Re: In the matter of the authorization of CSX Transportation to upgrade active warning devices as part of Galion – Union City Corridor Project in Marion County

TO: George Martin, Rail Division, PUCO
FROM: Cathy Stout, Manager, Safety Section, ORDC
BY: Joe Reinhardt, Project Manager, ORDC
SUBJECT: CSX Corridor, Two (2) Warning Device Projects, Marion County:
N. Greenwood Streets: DOT 518424S and DOT 262074P
DATE: December 23, 2014

RE: Marion County, N. Greenwood St., DOT 518424S
PID 96916, OH0992

Diagnostic Review Team Survey

Field Dimensions

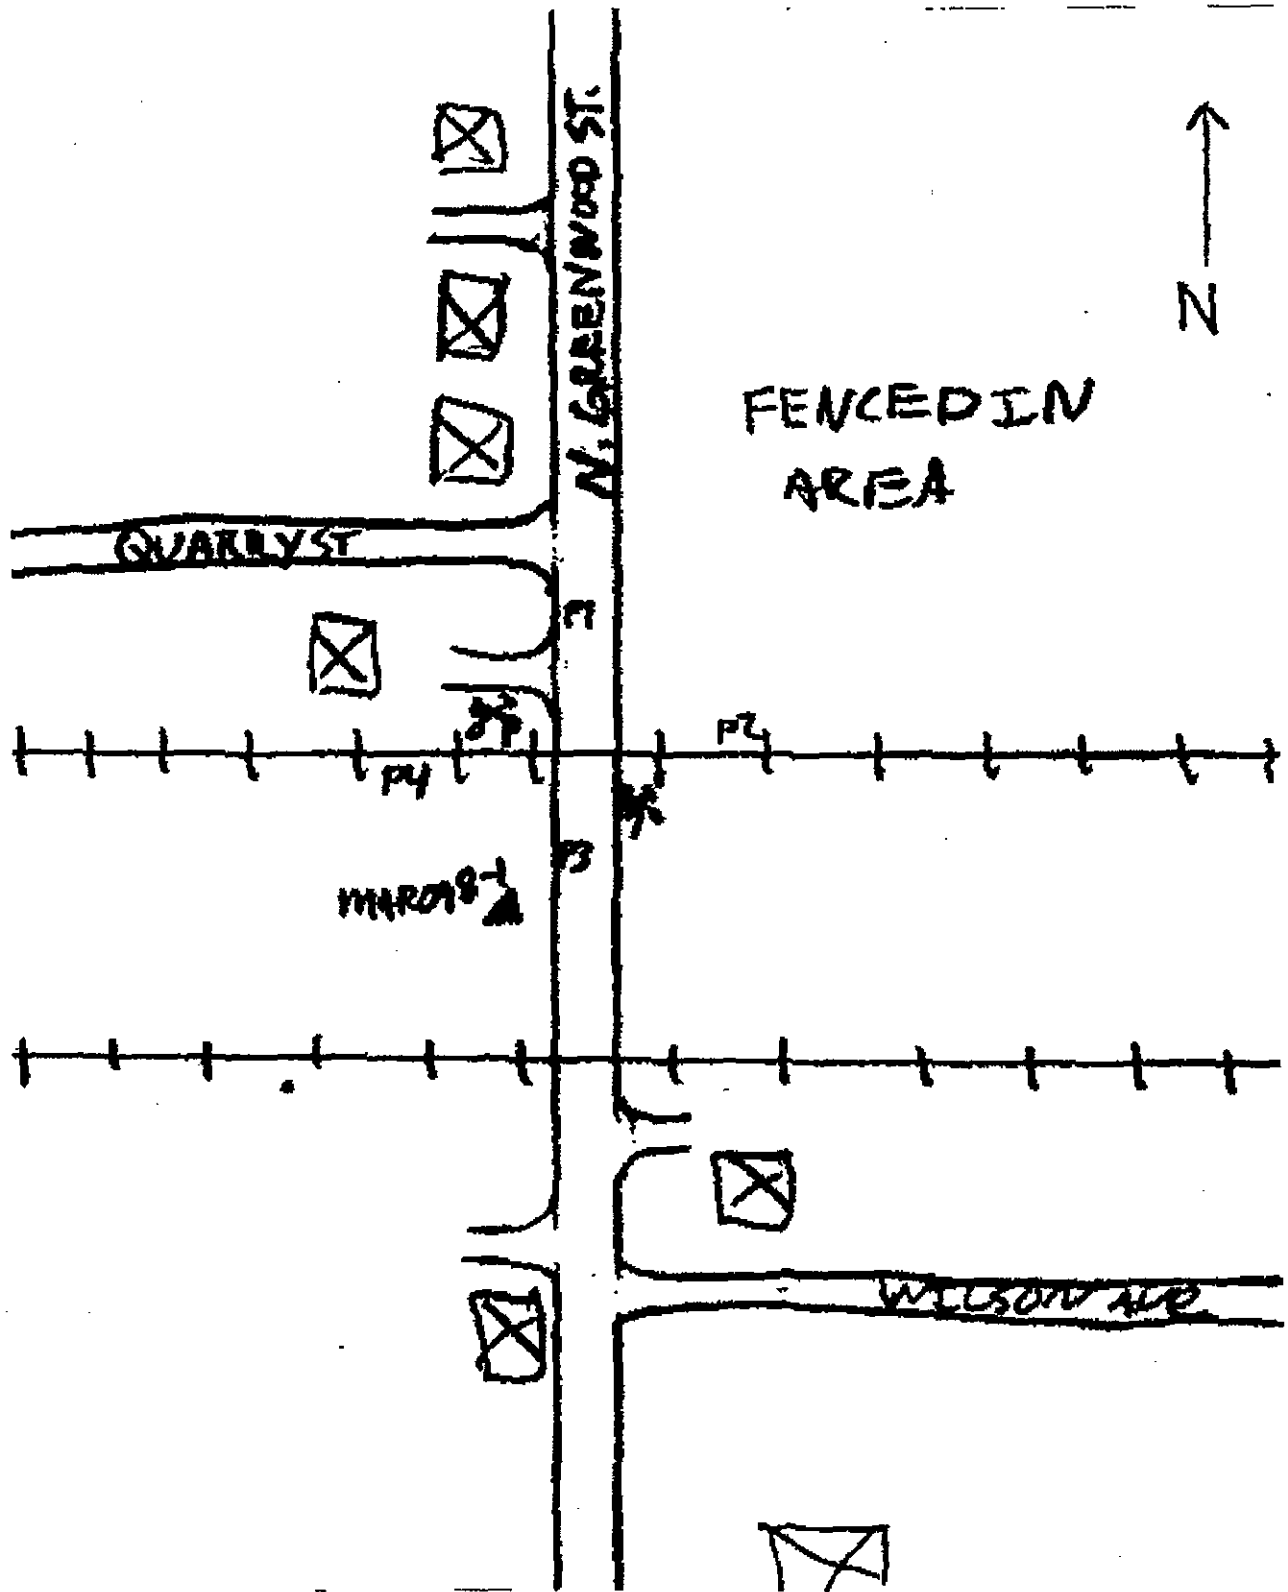
Quadrants Needed
<input checked="" type="checkbox"/> Install/upgrade active devices	
<input checked="" type="checkbox"/> Automatic Flashing Lights (AFLS)	2 - Inside Double Main
<input type="checkbox"/> AFLS / Cants	
<input checked="" type="checkbox"/> AFLS / Gates	2 - NW & SE QUADRANT
<input type="checkbox"/> AFLS / Gates / Cants	
<input checked="" type="checkbox"/> Bells / number	2 @ GATE LOCATIONS
<input type="checkbox"/> Upgrade circuitry / type	
<input checked="" type="checkbox"/> Sidelights	2 - SE QUADRANT
<input checked="" type="checkbox"/> Guardrail Needed	SE Quadrant
<input type="checkbox"/> Install/Replace curb	
<input type="checkbox"/> Bungalow placement & offset from rail & highway	
<input type="checkbox"/> Other (define)	
<p>Comments:</p> <p>Eliminate all RED Gates, ^{Gates} only inside double main tracks, SE Quad install 15-12' with a guardrail & NW Gate to AREMA Standards. The MAIN TRACKS ARE APPROX 132' APART</p>

MAR N Greenwood St 262074P

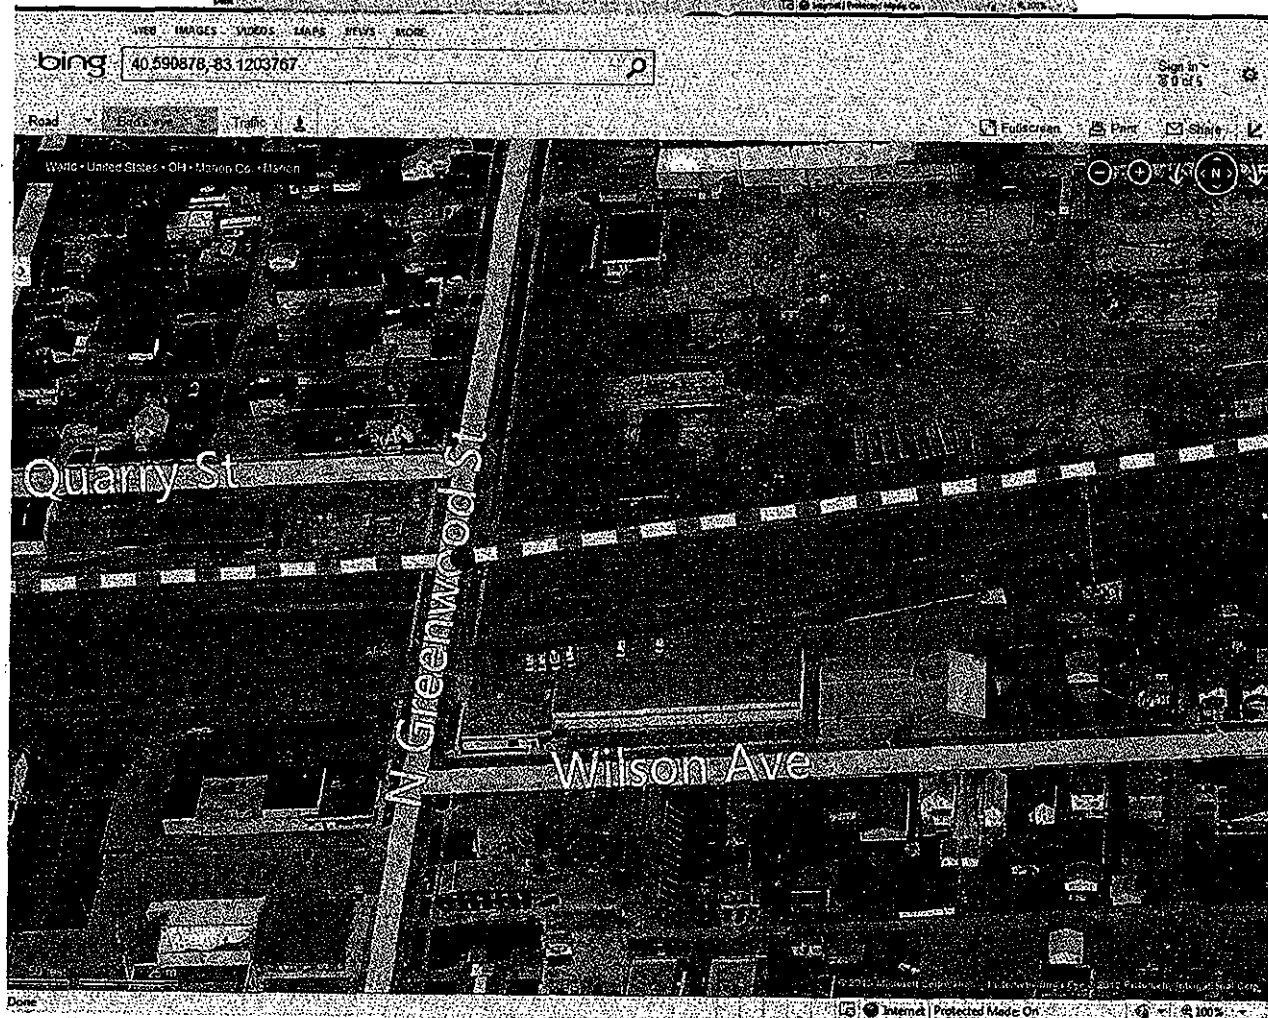
The plan and estimate dated November 13, 2014, for the referenced project has been reviewed and is acceptable with the following exceptions: A) curbs will be installed and move foundations between sidewalks and roadway at 4'3". CSX may proceed with the construction of the proposed grade crossing warning system in accordance with the abbreviated plan. This authorization is made with the stipulation and understanding that the approved estimate may contain entries for items or activities that may be cited and found to be ineligible for federal participation during the project audit. Reimbursement of eligible actual cost is limited to \$157,109. Additional costs must be approved in writing by the ORDC prior to being incurred. Emergency verbal authorizations by ORDC may be permitted and will be confirmed by ORDC in writing within ten (10) business days of the verbal approval.

MAR N Greenwood St 518424S

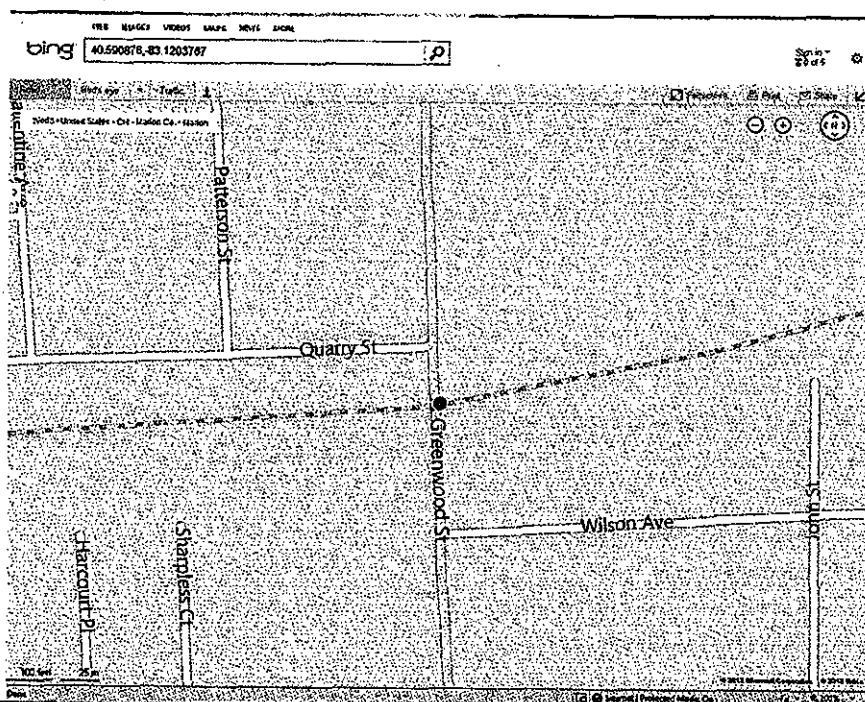
The plan and estimate dated November 13, 2014, for the referenced project has been reviewed and is acceptable with the following exceptions: A) curb with be installed for the NW quadrant foundation and a ½ or full guardrail used at the SE quadrant foundation. CSX may proceed with the construction of the proposed grade crossing warning system in accordance with the abbreviated plan. This authorization is made with the stipulation and understanding that the approved estimate may contain entries for items or activities that may be cited and found to be ineligible for federal participation during the project audit. Reimbursement of eligible actual cost is limited to \$149,453. Additional costs must be approved in writing by the ORDC prior to being incurred. Emergency verbal authorizations by ORDC may be permitted and will be confirmed by ORDC in writing within ten (10) business days of the verbal approval.
